DUBLIN COUNTY COUNCIL

REG. REF.: 91A/1201

RE: House at 1 Woodfarm Cottages, Old Lucan Upper, Palmerstown, for N. Cleary.  
-----

Proposed change from approved bungalow to 176 sq.m. dormer bungalow, conservatory and revised recessed entrance at rear of 1 Woodfarm Cottages, Old Lucan Road, Palmerstown Upper for Noel Cleary.

I attach copy of Drawing No. Dev. P.26/1 showing the plot in question  
and I should be obliged if you would let me have your observations on this  
proposed disposal and let me know if your Department would have any objection  
to the disposal of this plot by the Council.

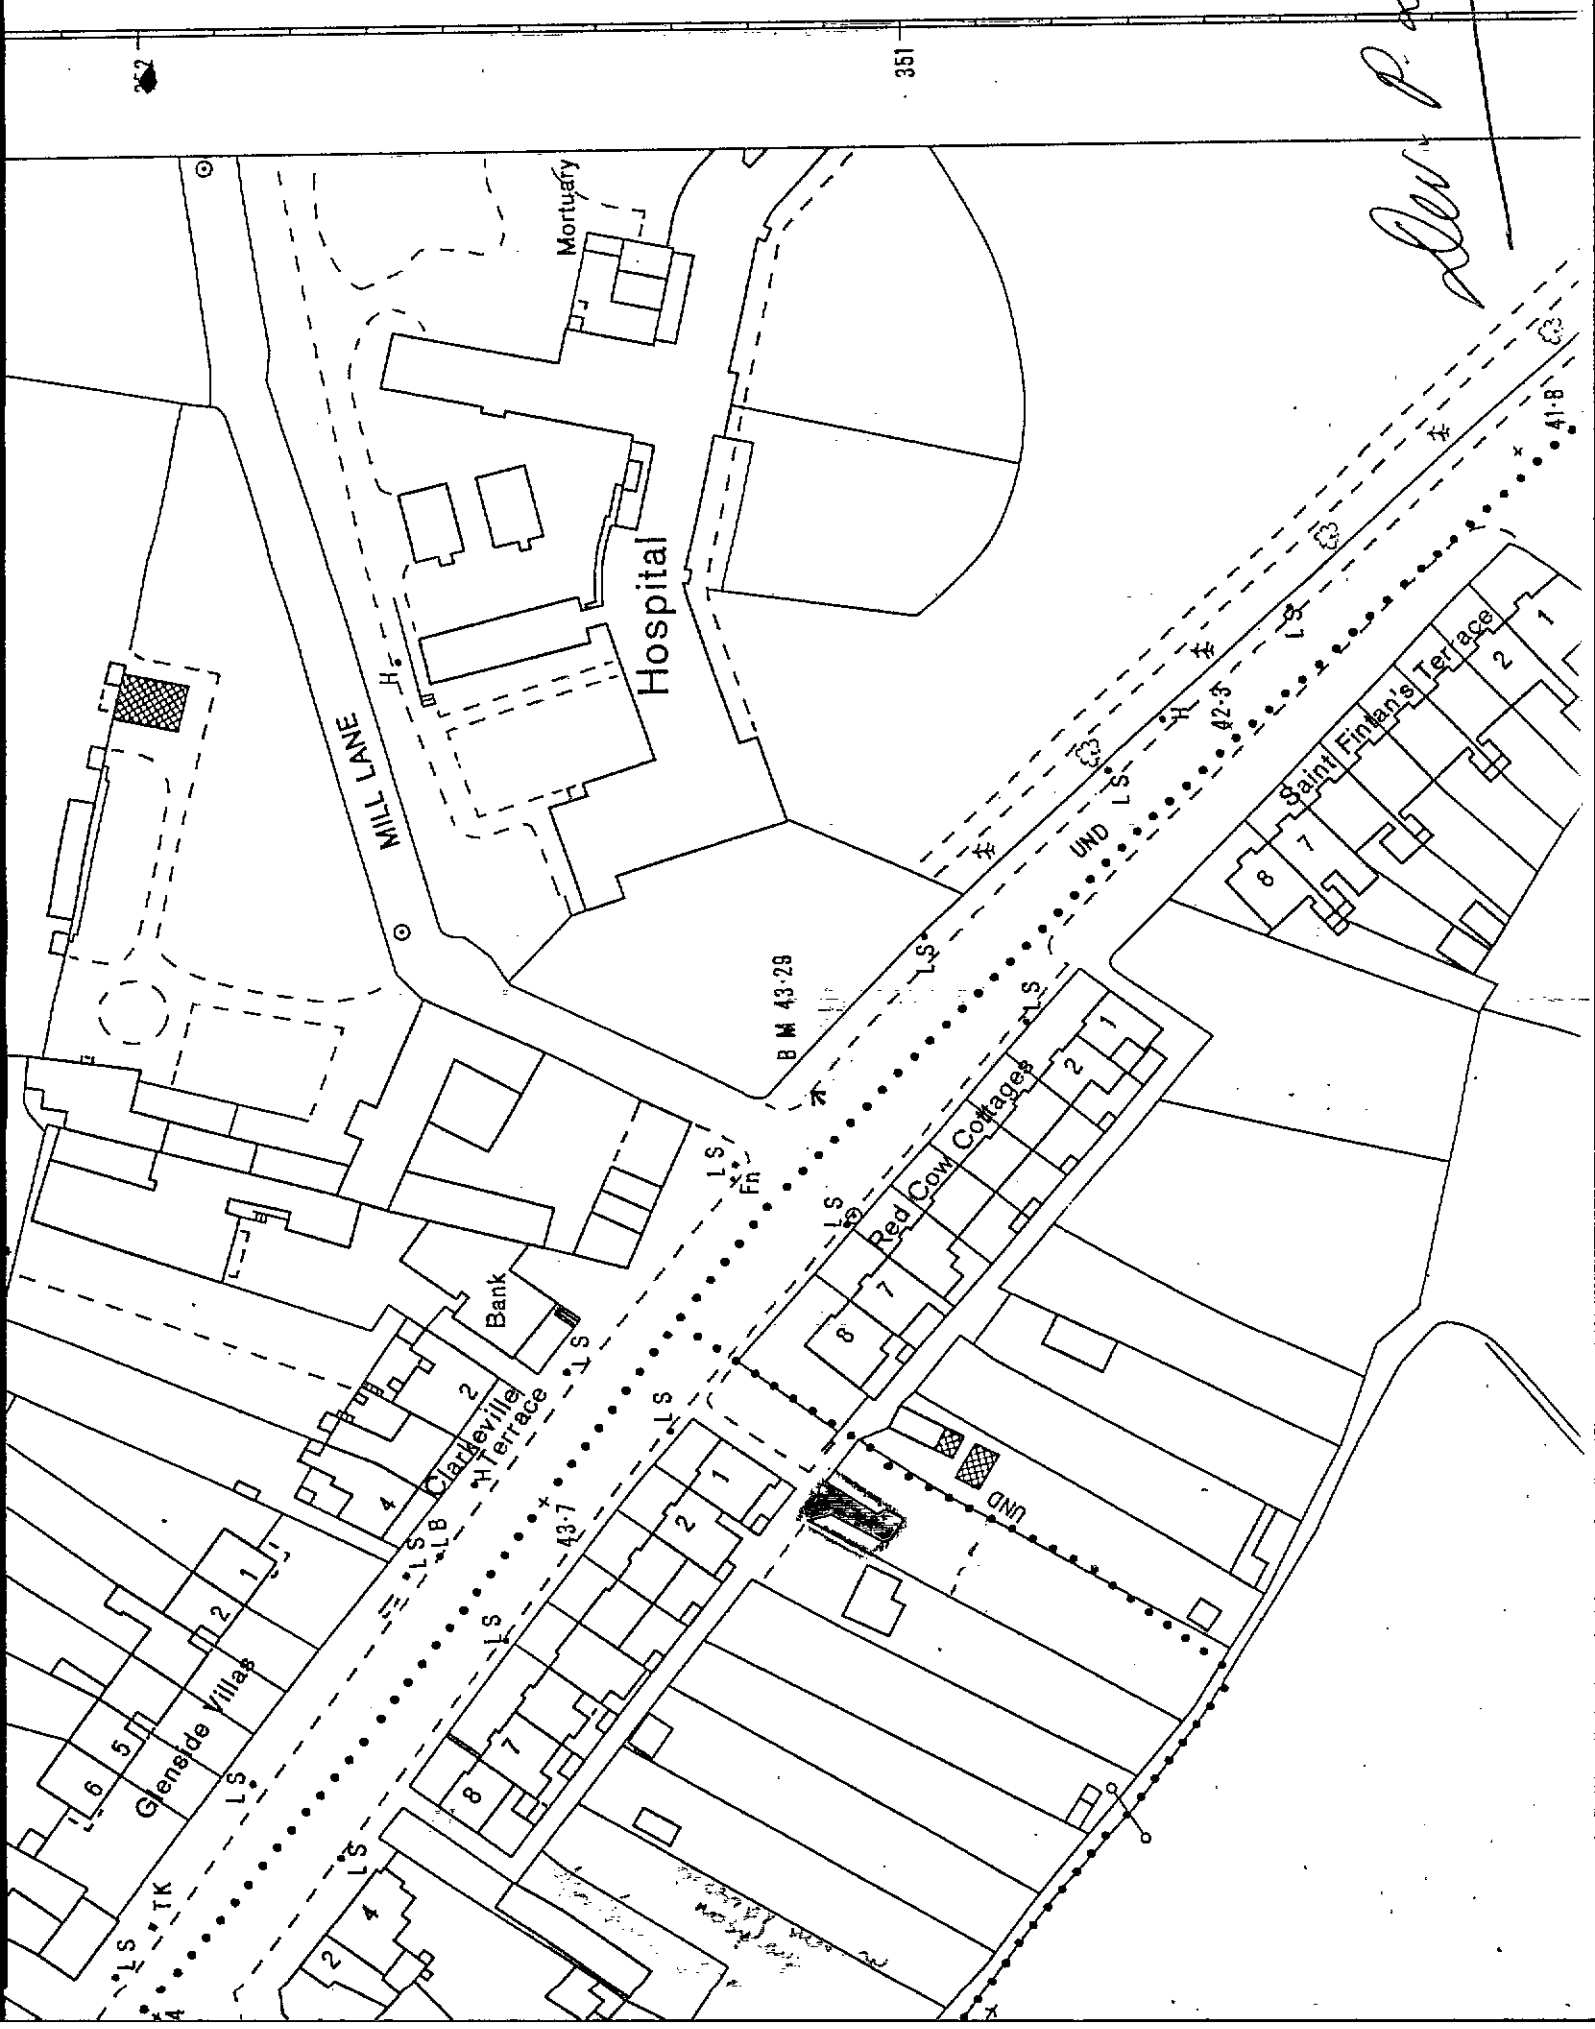
An application has been received from Mrs Mary Byrne  
of 6 Esker Park, Lucan, Co. Dublin for the purchase  
of a disused pump site at Woodfarm Cottages, Palmerstown.

The land is required by the applicant for incorporation with adjacent lands  
on which she proposes to construct a bungalow.

The pump site is currently completely overgrown and impenetrable. The adjoining lands into which it is proposed to incorporate the site are also not being maintained. There would be no objection in principle to the proposed disposal of the pump site for incorporation into the adjoining lands as a prelude to the construction of a bungalow. Such a disposal would however have to be on the basis that it would not prejudice the terms of any planning permission for a bungalow, specifically in relation to any front boundary setback requirements required for access along the laneway. I recommend that the Development Department be advised accordingly.

DRG. NO. 10 (SECTION OF APPLICATION)  
 SCALE: 1" = 10' DRWG. NO. 2, JUNE 1991  
 LANDS TO BE CEDED TO  
 DUBLIN CO. CO. OUTLINED RED.

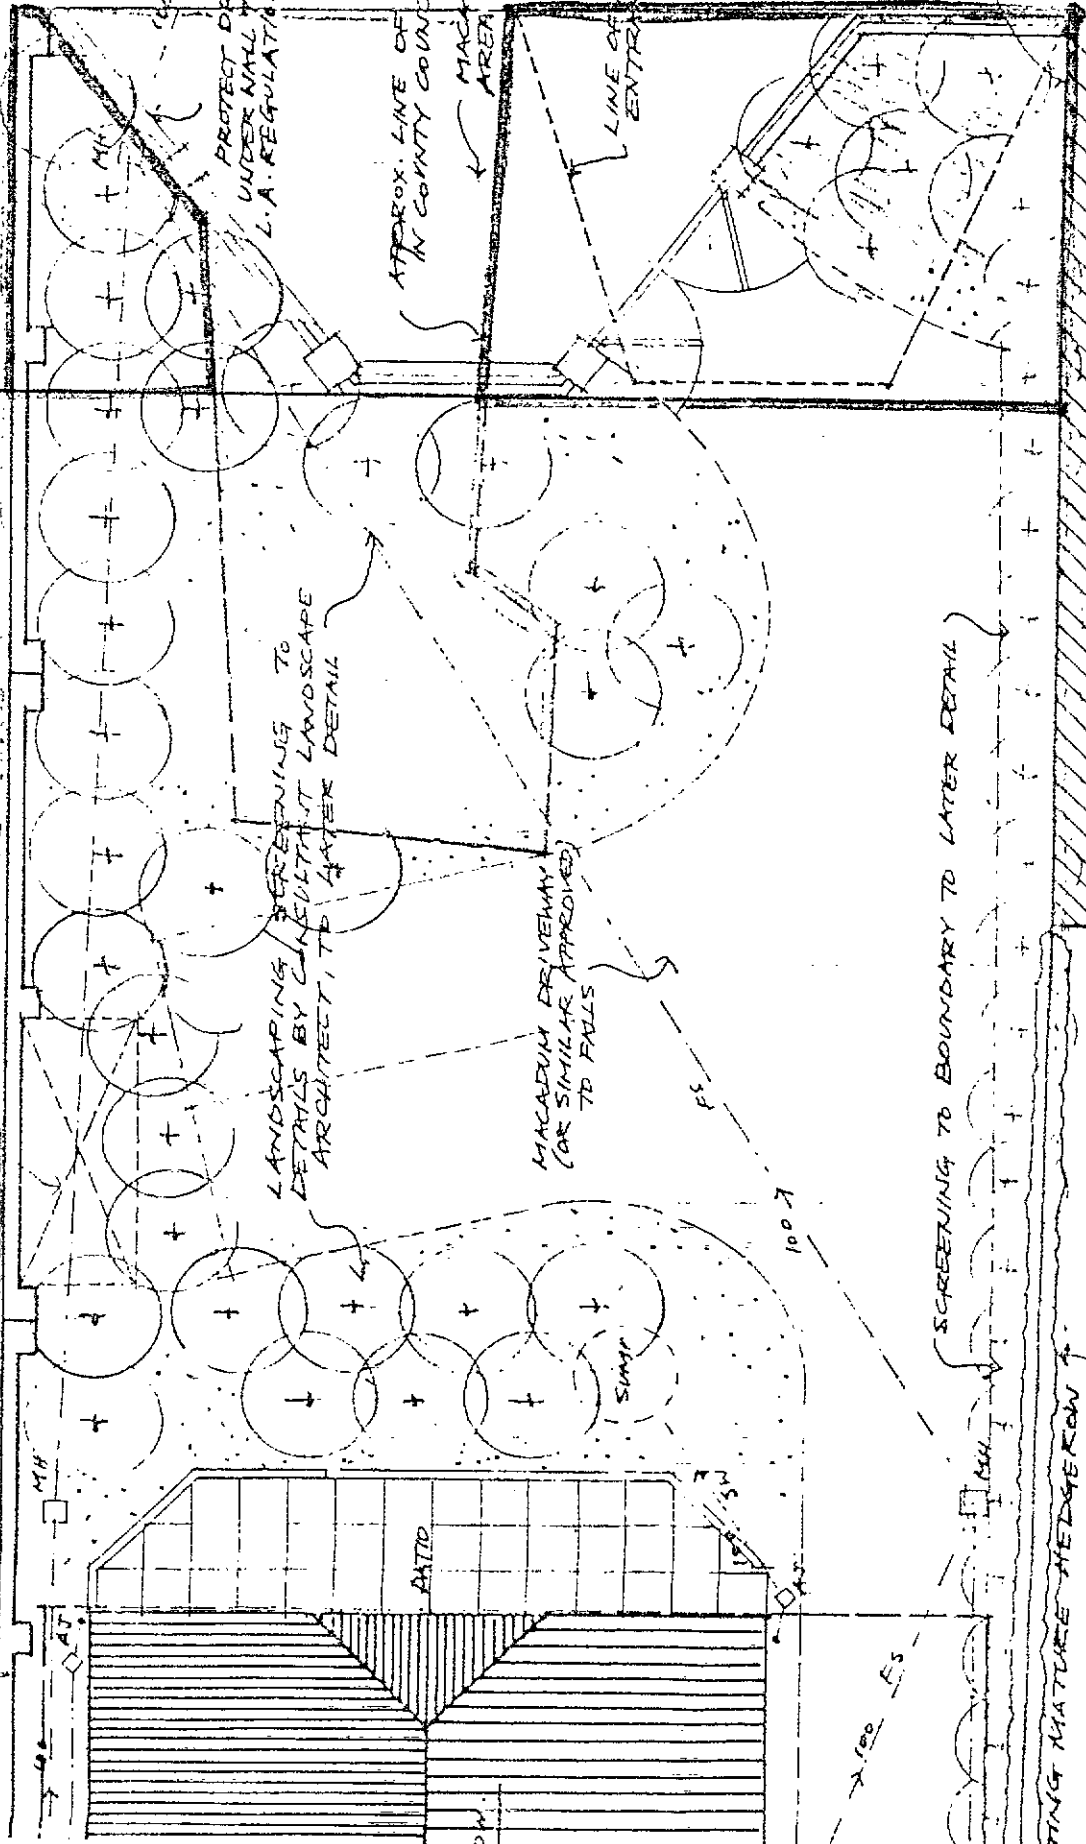
1. The applicant shows incorporation of an area of land in the ownership of Dublin County Council into his front garden. The applicant is asked to clarify on what authority he is taking possession of this land.
2. The proposed development does not provide satisfactory access to the site or allow for future satisfactory access to the adjoining lands. The applicant is asked to clarify if he is in a position to improve his access from his site to the Old Lucan Road and to improve the access to adjoining lands.

Further to our meeting to-day with Ms Mary Galvin, Dublin Co.Co., in connection with above proposed development, the applicant hereby agrees to cede to Dublin County Council, the lands outlined red on the enclosed map, on the understanding that a favourable Planning Permission be granted for the development proposed, that the area to be ceded remains in the applicants control until such time that sufficient development in the area warrants the widening of the existing laneway, and that a temporary recessed access to the site is agreed.
